**TOWN OF MOUNTAIN VILLAGE
REGULAR DESIGN REVIEW BOARD MEETING AGENDA
THURSDAY SEPTEMBER 7, 2023, 10:00 AM
MOUNTAIN VILLAGE TOWN HALL
455 MOUNTAIN VILLAGE BLVD, MOUNTAIN VILLAGE, COLORADO
TO BE HELD HYBRID THROUGH ZOOM:
<https://us06web.zoom.us/j/81245118996>
Meeting ID: 812 4511 8996**

**DESIGN REVIEW BOARD MINUTES
TOWN OF MOUNTAIN VILLAGE
REGULAR DESIGN REVIEW BOARD MEETING
SEPTEMBER 7, 2023**

AGENDA ITEM 8
PLANNING & DEVELOPMENT SERVICE
PLANNING DIVISION
455 Mountain Village Blvd.
Mountain Village, CO 81435
(970) 728-1392

SHEET #
C7

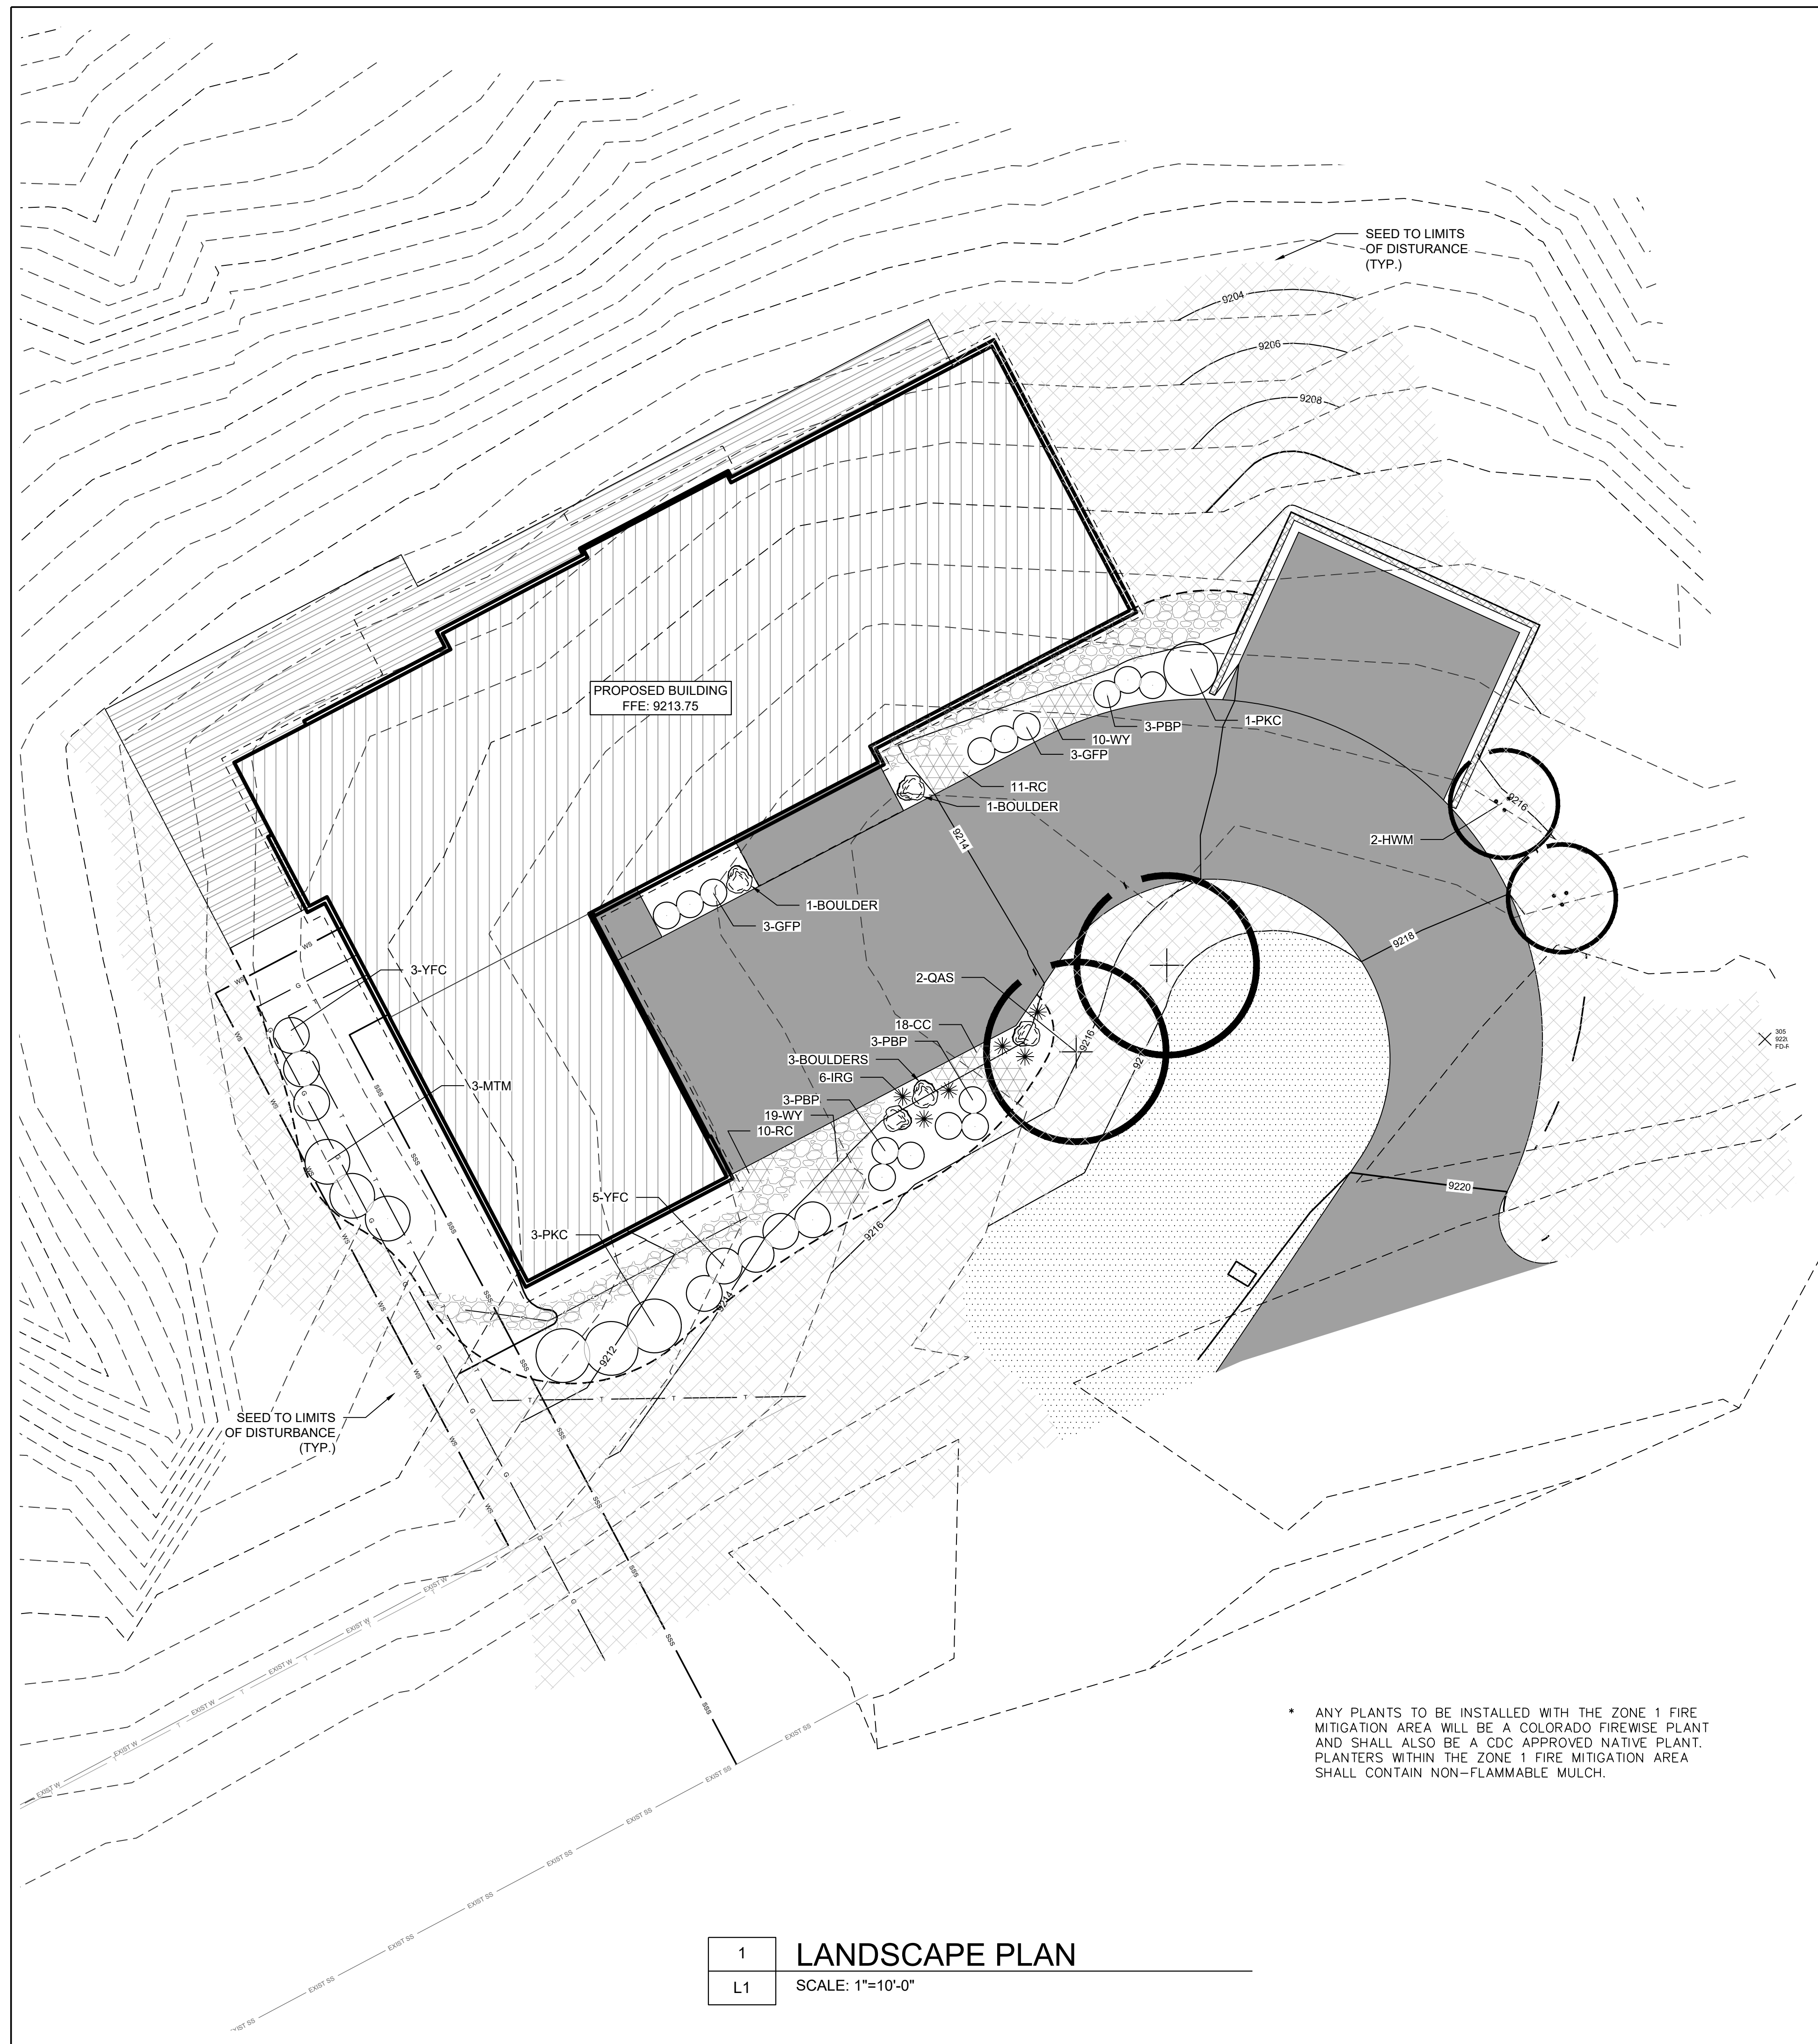
Staff: As a condition for the final review, the applicant was to revise the fire mitigation plans per the comments of the Town Forrester. The applicant provided an updated Fire Mitigation Plan on Sheet C7 showing the removal of Evergreen trees and the placement of deciduous plants in Zone 1. Additionally, the required notes recommended by the Town Forrester are included on sheets C7, L1 and L2.

Sheet C7: Needs to have the trees to be removed marked in a color to differentiate them from the trees that are planned for retention. A note for Fire Mitigation Zone 1 needs to state, "All trees and shrubs located within Zone 1 shall be removed. Any vegetation that is planned for installation in Zone 1 shall be a Colorado Firewise plant and shall also be a native species as listed in the CDC Landscape Regulations (CDC 17.5.9.)". A note for Fire Mitigation Zone 2 needs to state, "Before excavation begins, the Town Forester shall be contacted to mark trees for removal in Zone 2. Zone 2 vegetation shall be managed in such a way that trees or groups of trees greater than 4" diameter at breast height (dbh) shall have a crown separation of 10 feet, all ladder fuels and slash shall be removed from the 10' crown-to-crown separation area, and shall be removed, and shrubs over 5' tall shall have an average spacing of 10' from shrub-to-shrub. Any trees that are planned for retention within the limits of disturbance shall have tree protection fencing indicated to at least the dripline of the trees. The plan needs a note stating, "No backfill, storage, or staging is permitted inside the tree protection areas inside the tree protection fencing". In denoting the trees that will be removed, carefully consider space needed for excavation and construction, the backfill requirements that will be needed around the driveway and retaining walls, and the onsite space that may be needed for soil storage/staging.

- 1) Prior to final review the applicant will revise the fire mitigation plans per the comments of the Town Forrester.
Response: Please see the revised Fire Mitigation Plan on Sheet C7. Evergreen trees have been removed from Zone 1. The requested notes have been added to Sheet L1 and L2.

SHEET # **L1**

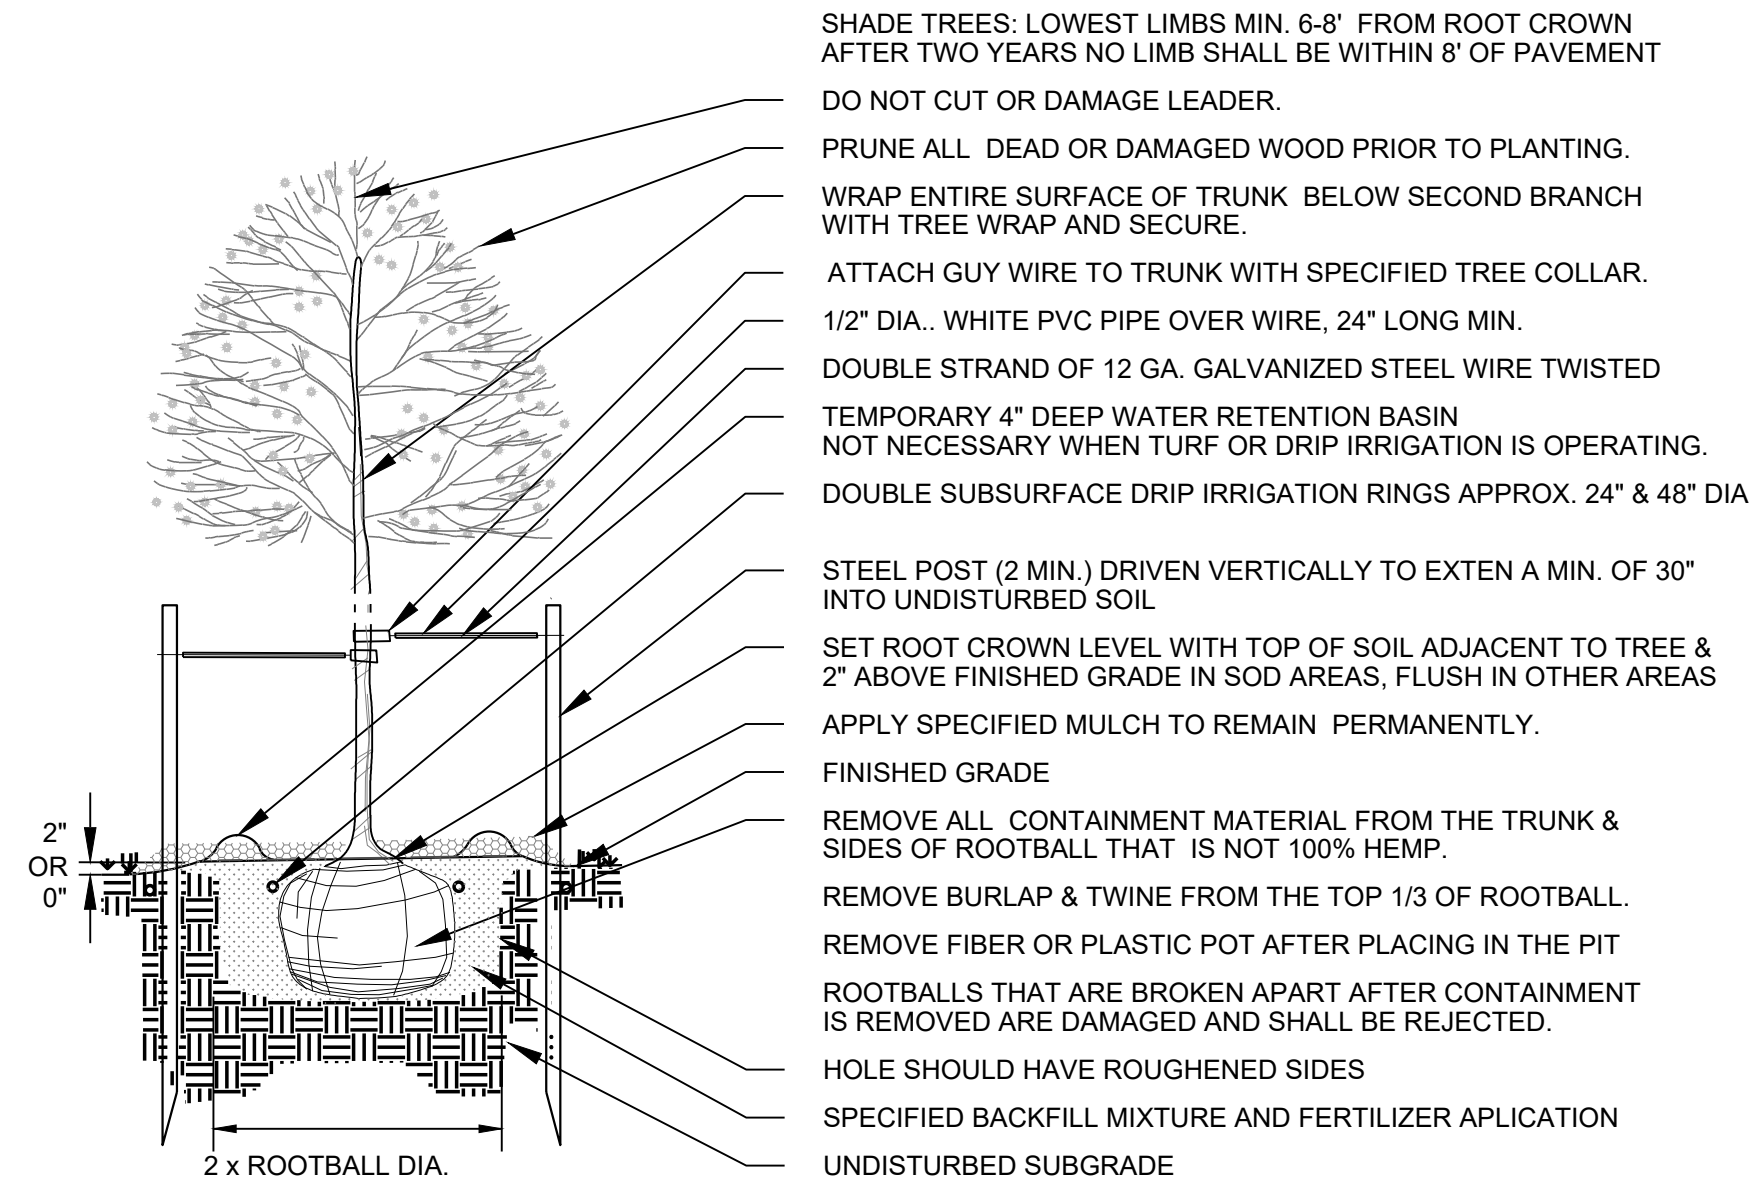
Sheet L1: The plan shows an evergreen tree (flammable plant) to be planted within the Zone 1 fire mitigation area. Please indicate and deciduous plant in this location. This sheet needs a note stating "Any plants to be installed within the Zone 1 fire mitigation area will be a Colorado Firewise plant and shall also be a CDC approved native plant. Planters within the Zone 1 fire mitigation area shall contain non-flammable mulch."

Sheet L1: The plan shows an evergreen tree (flammable plant) to be planted within the Zone 1 fire mitigation area. Please indicate and deciduous plant in this location. This sheet needs a note stating “Any plants to be installed within the Zone 1 fire mitigation area will be a Colorado Firewise plant and shall also be a CDC approved native plant. Planters within the Zone 1 fire mitigation area shall contain non-flammable mulch.”

DIRECTORY
IRRIGATION SCHEDULE IRO
IRRIGATION NOTES IRO
IRRIGATION PLANS IR1
IRRIGATION DETAILS IR2 - IR3

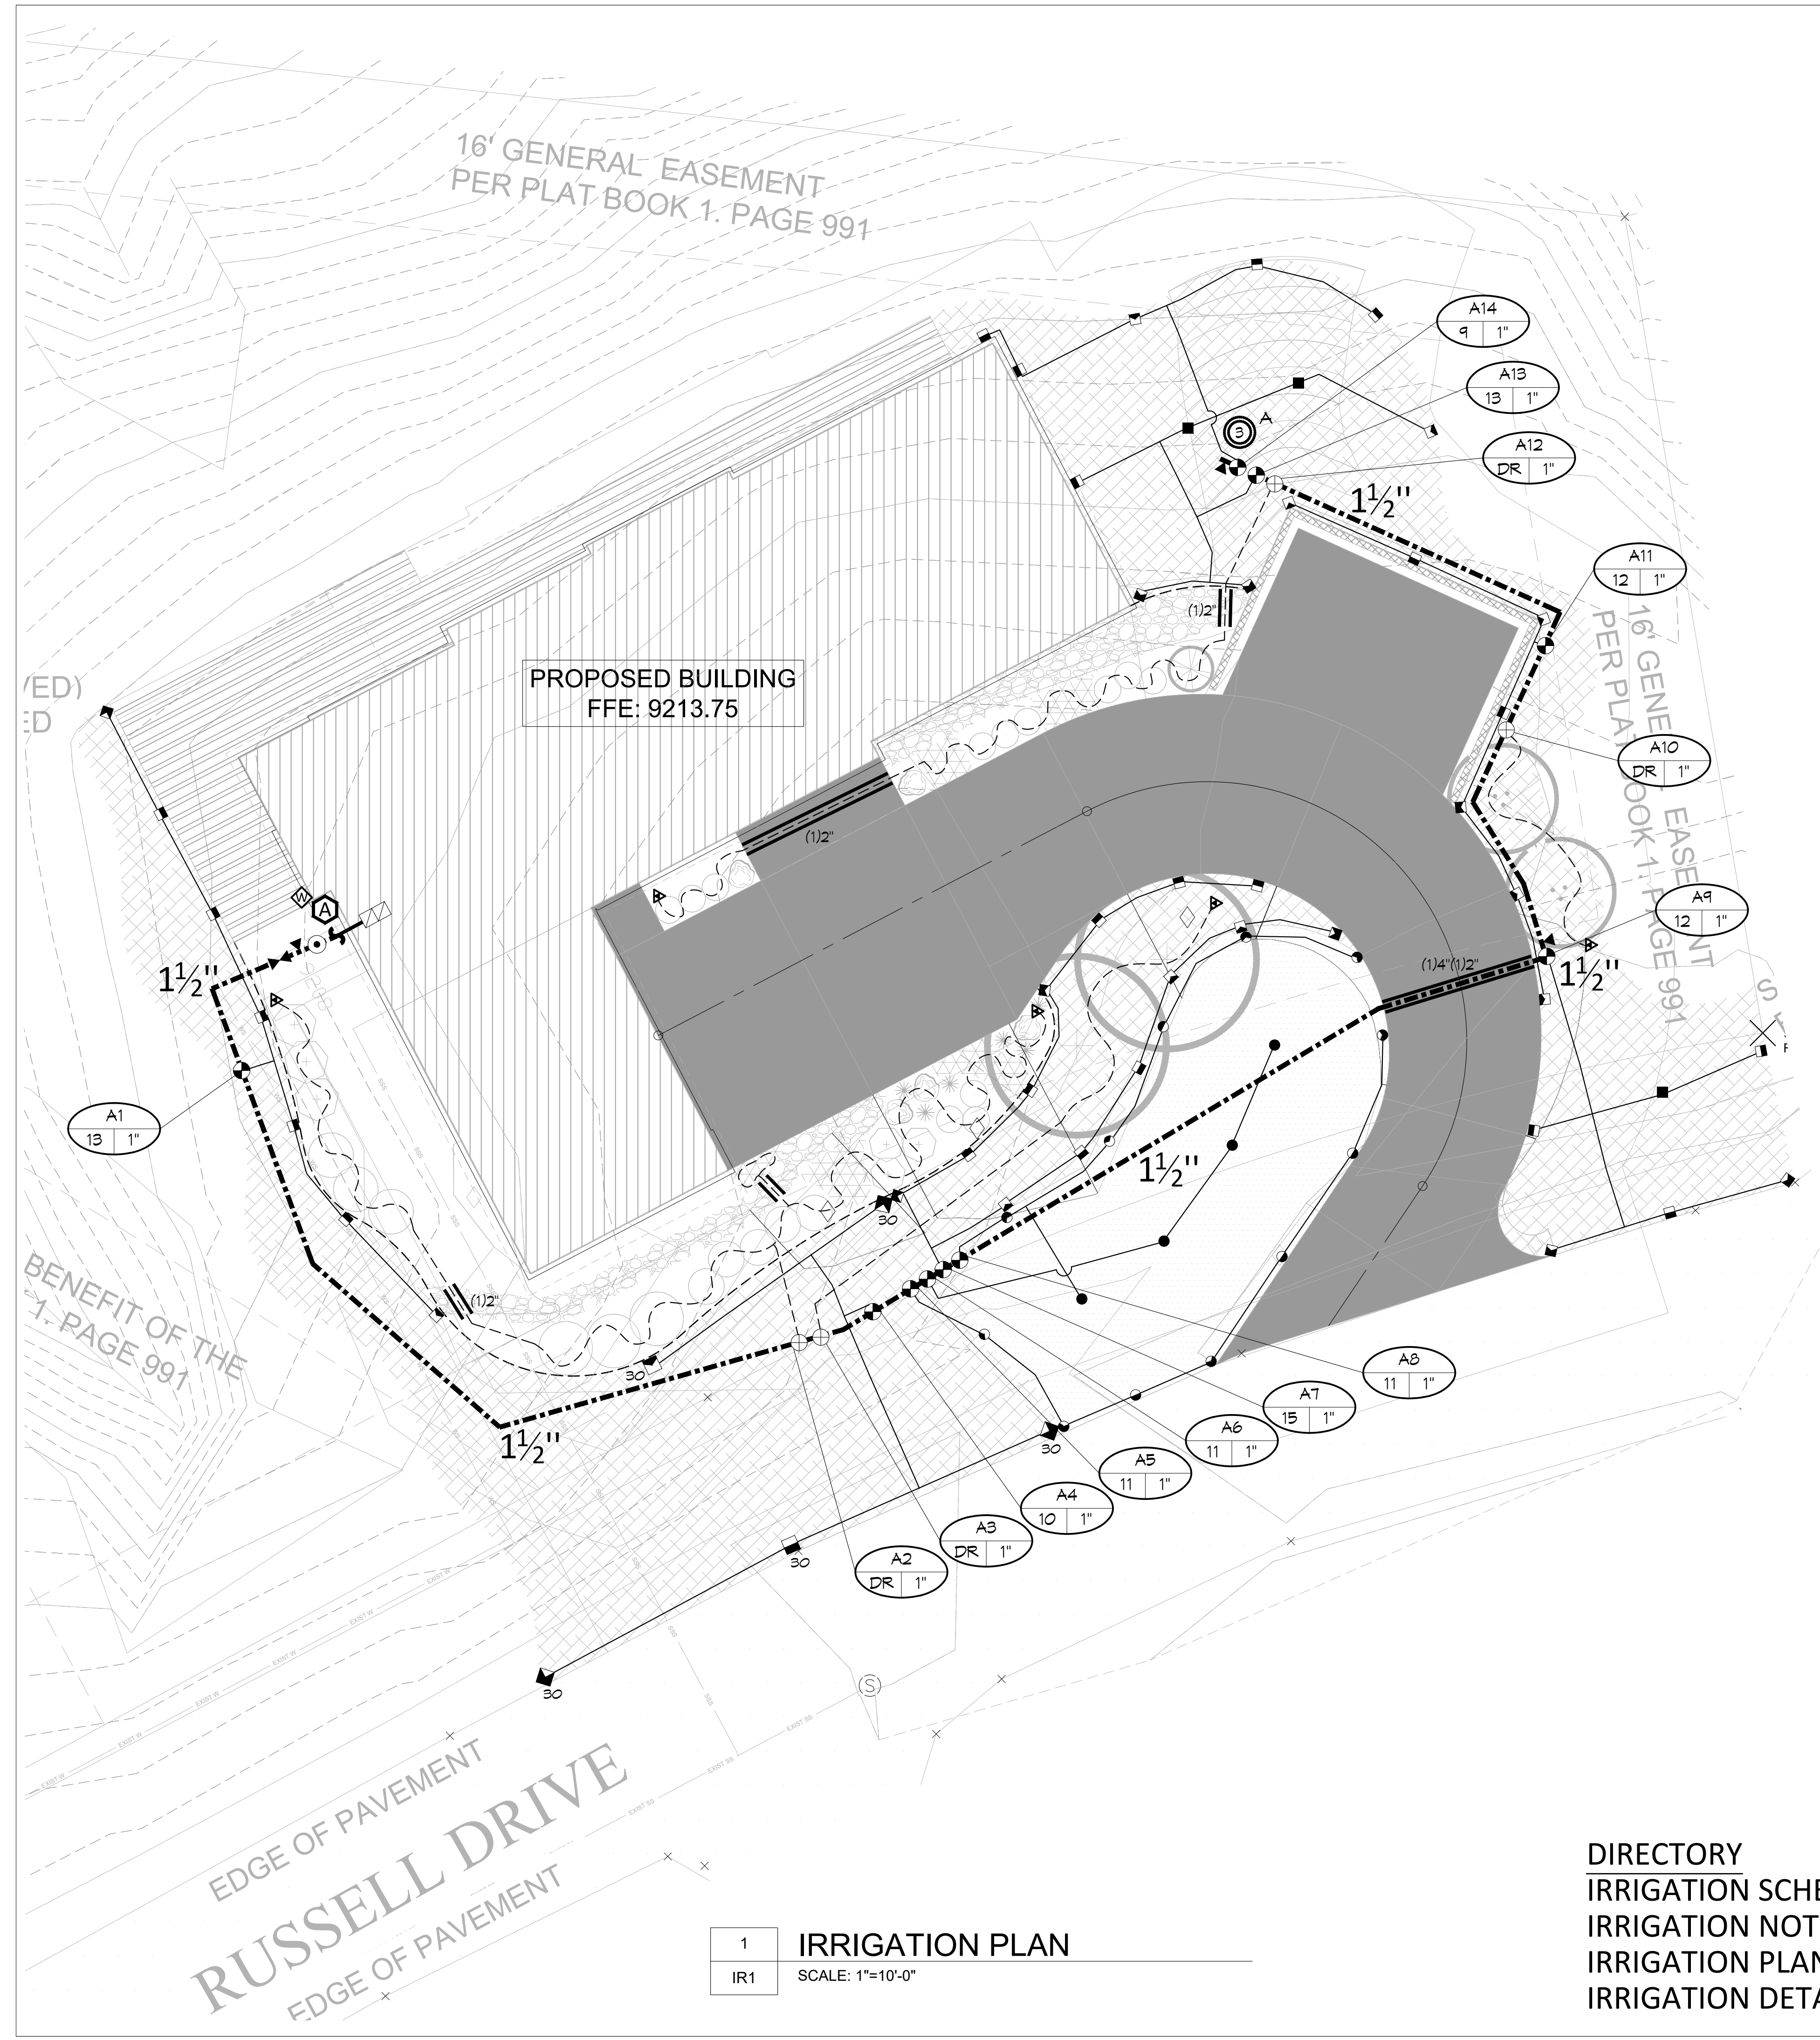
The applicant has indicated that irrigation will be required for the landscaping in the GE. As part of the FAR plan set the applicant was required to provide irrigation locations to determine the extent of the GE impacts. The updated irrigation plans are included on Sheets IR0-IR3. The plans do not clearly illustrate the location of the irrigation in relation to the GE. Staff has provided an estimate of the GE based on the faint linework in the drawing. This illustrates irrigation lines in the GE and within the Right-of-Way. Per the CDC requirements, irrigation is not permitted in the right-of-way. A revised Irrigation Plan is required for review by staff, prior to building permit.

Staff: As a condition for final review the applicant was to revise the landscaping plans per the comment of the Town Forrester and include proposed irrigation specifications and locations. The applicant has updated the landscape plan to include the Town Forrester's notes and proposed irrigation specifications on sheets IR0-IR3.
